CONSTRUCTION SUMMARY

Lindsay 2017 Developments Inc. / Sugarwood

Lot/Unit: 45 Phase/Building: 1 Model/Floor Plan: White Lake (4204) Elev A 3Bed 2.5Bath

Sketch #1

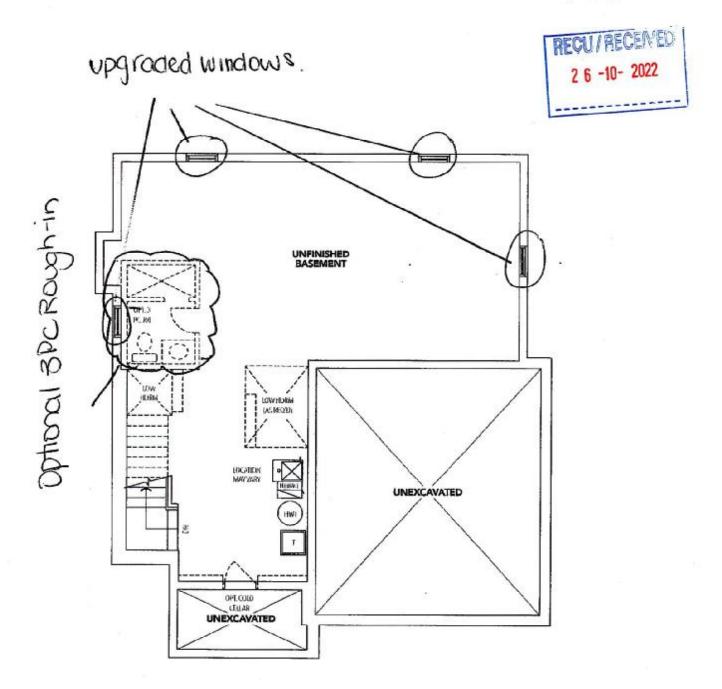
Inv. 5944	4 - To supply and install basement windows sized 36x24" in lieu of the standard size see	
	sketch #1 for details	
Line 75281	Note: IF UNABLE TO ACCOMODATE THE PURCHASER WILL BE CREDITED ON CLOSING	
25Oct22 / 26Oct22

Inv. 5944	1 - To supply and install the 3PC Rough-in in the unfinished basement see sketch #1 for details	
Line 75280	Note:	
25Oct22 / 26Oct22
